Re: Novak Sanitary Landfill Site ("Site"); Comments on
the May 1993 Proposed Remedial Action Plan ("PRAP")

The following comments on the PRAP are submitted to the United States Environmental Protection Agency ("EPA") on behalf of the Novak RI/FS PRP Group ("Group"). These comments have been prepared by the Chairperson of the Group, Lawrence W. Diamond of Hannoch Weisman; the Project Coordinator, Mark Travers of de maximis, inc.; and the Group's consultants, Geraghty & Miller, Inc. and Vincent Uhl Associates, Inc.

FIGURE
4-15

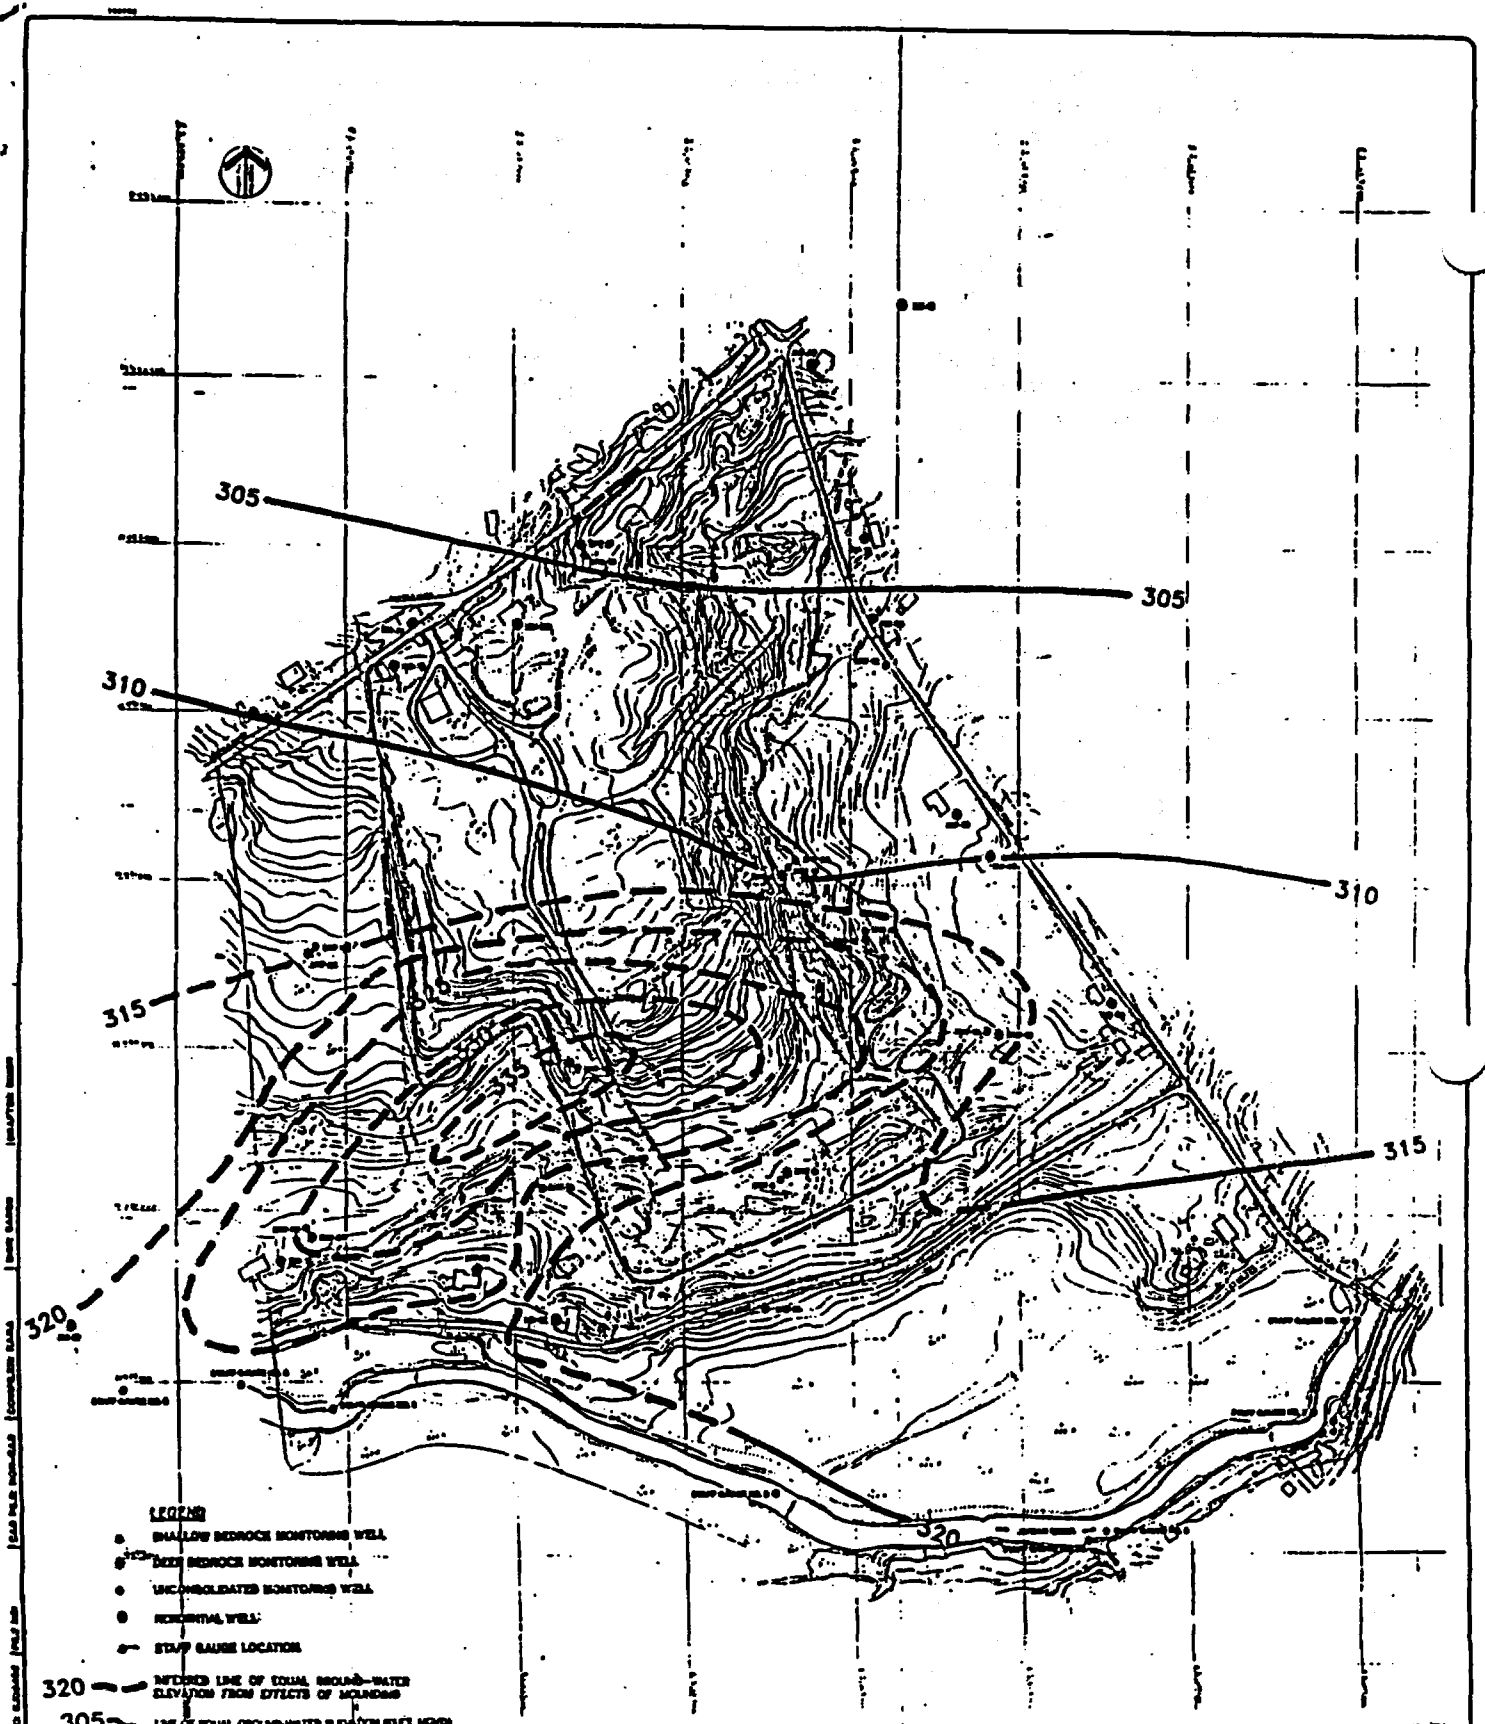
A groundwater mound is present below the Trench Fill Area (Figure 4-15 from RI attached) as a result of the enhanced recharge from landfill activities as well as the inherent low hydraulic properties of the bedrock system in this area. Computer modelling was performed to first simulate the present mounding condition and secondly to simulate the decline of the mound after a single barrier cap had been installed on the Trench and Surface Fill Areas.

FIGURE
1

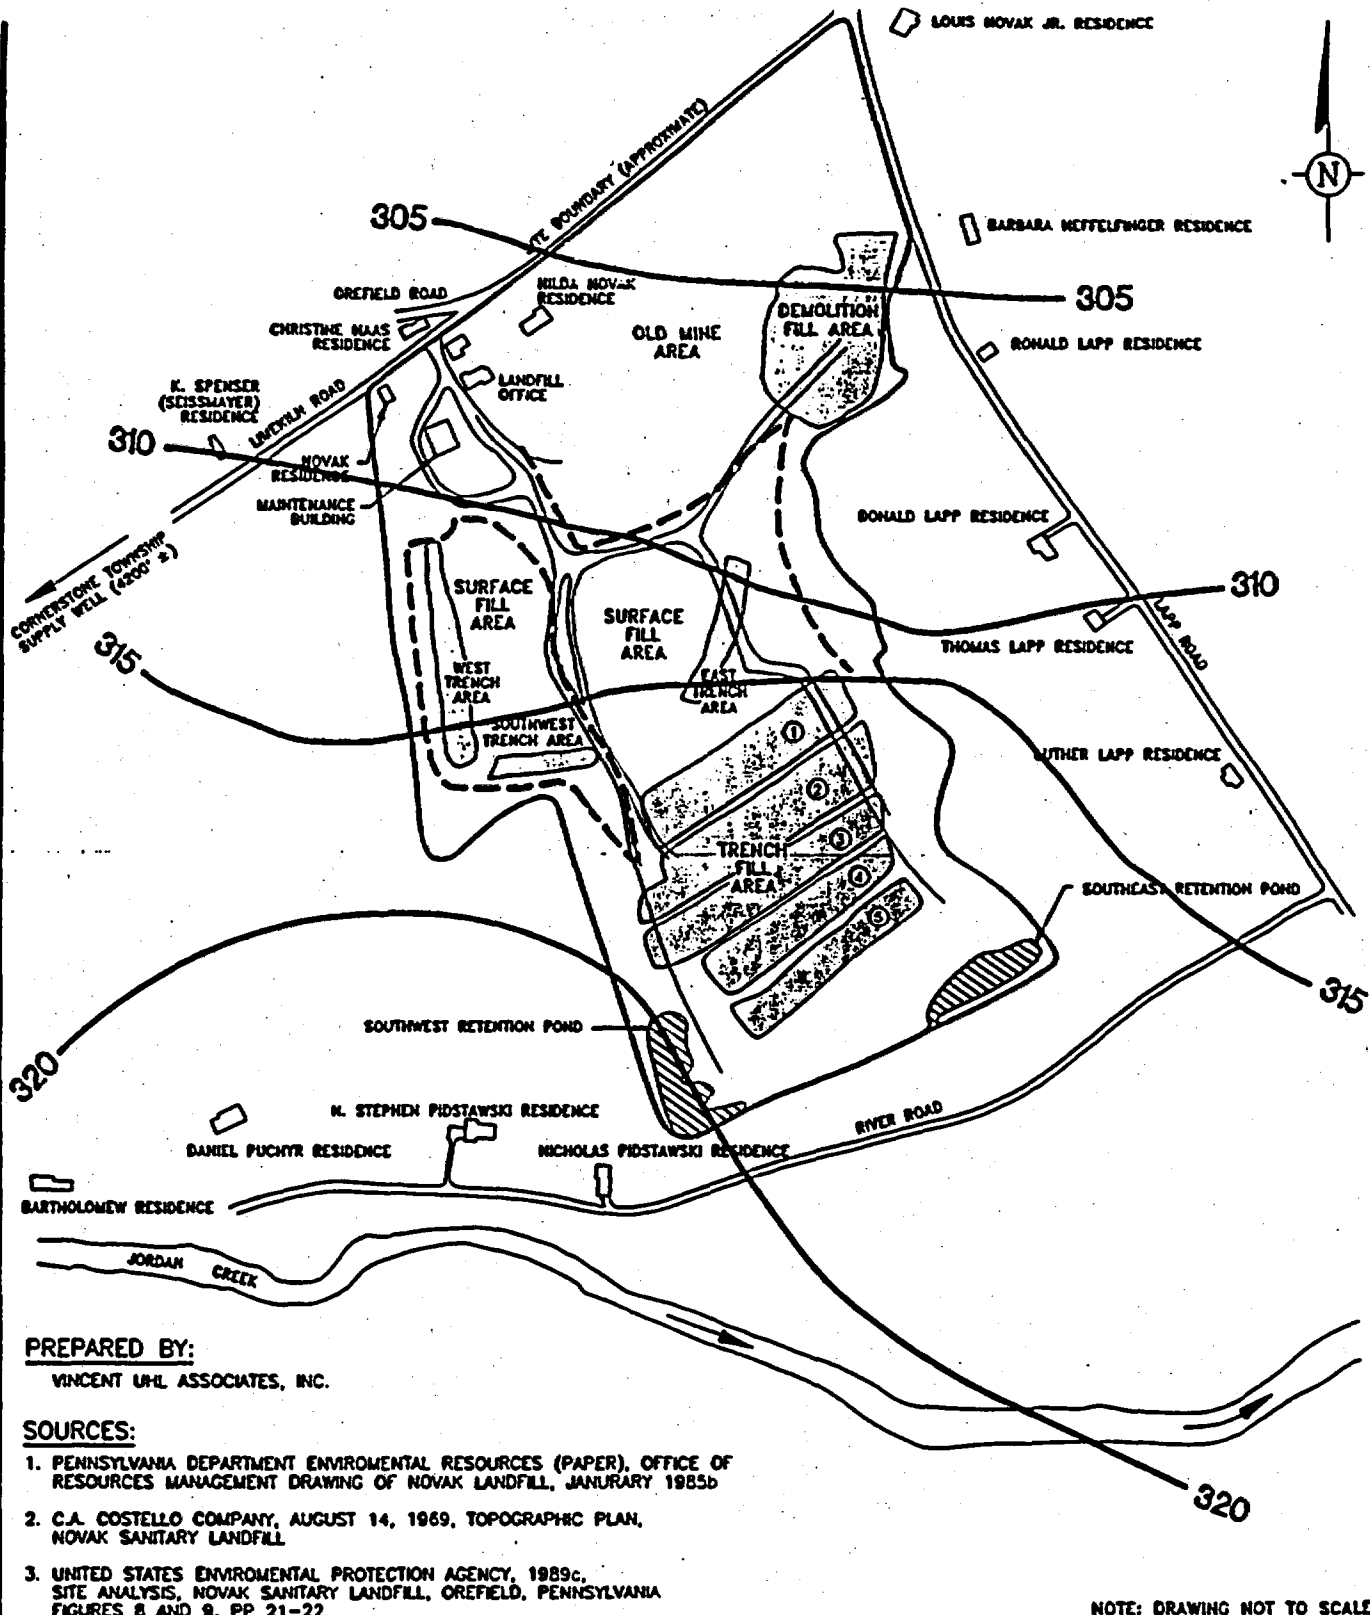
Based on the model predictions, a water-level contour map was developed for a period 6 years after the cap had been installed (Figure 1 attached). This map depicts the return to natural groundwater flow conditions.

DECISION TREE FOR SELECTING REMEDIAL GOALS FOR GROUND WATER

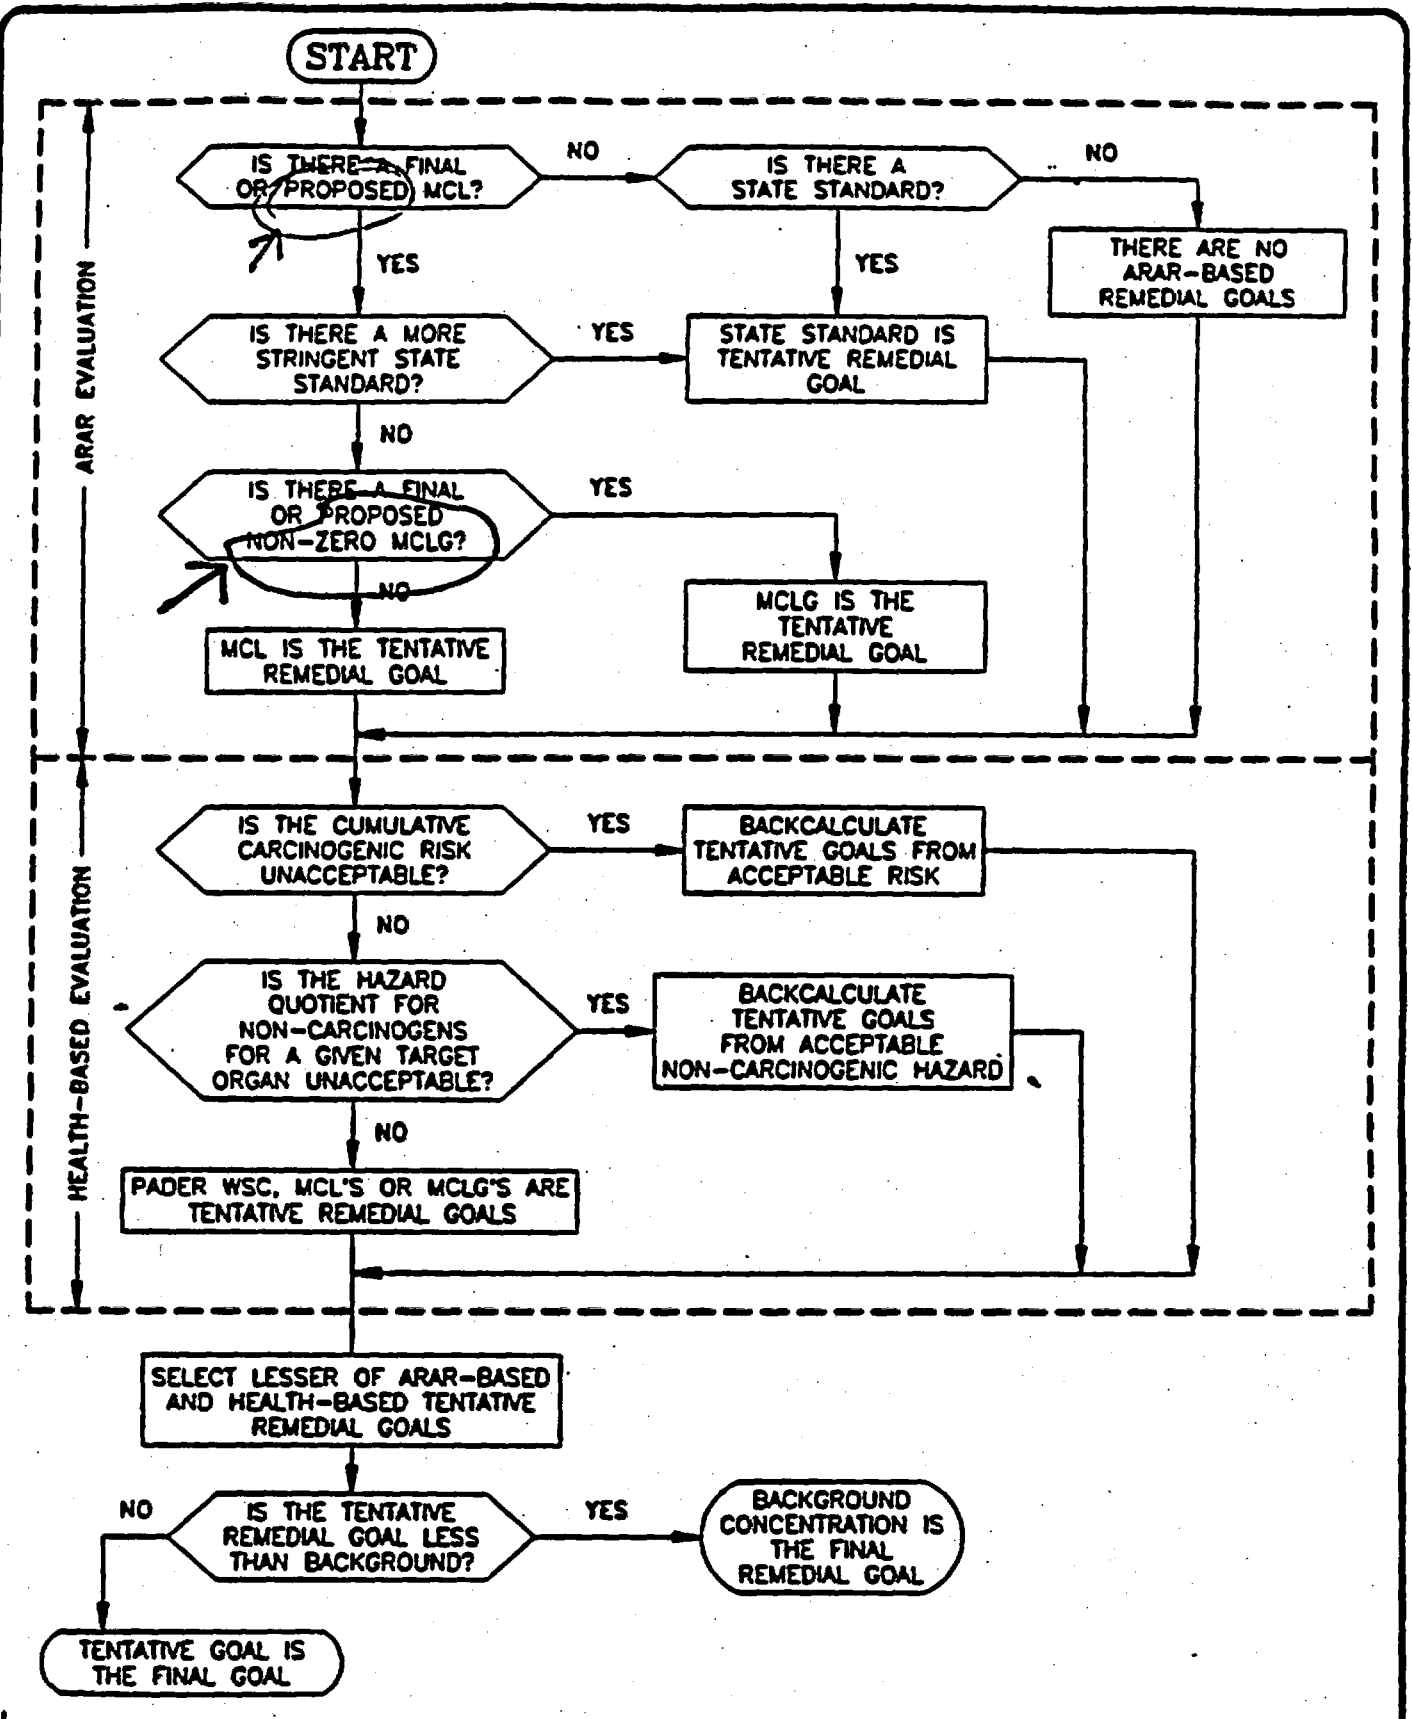
3. Pages 2-19 and 2-20 of the January 21, 1993 final FS cites that you must follow the "Decision Tree" on Figure 2-1 (Attachment D) in obtaining the values for Table 2-58.
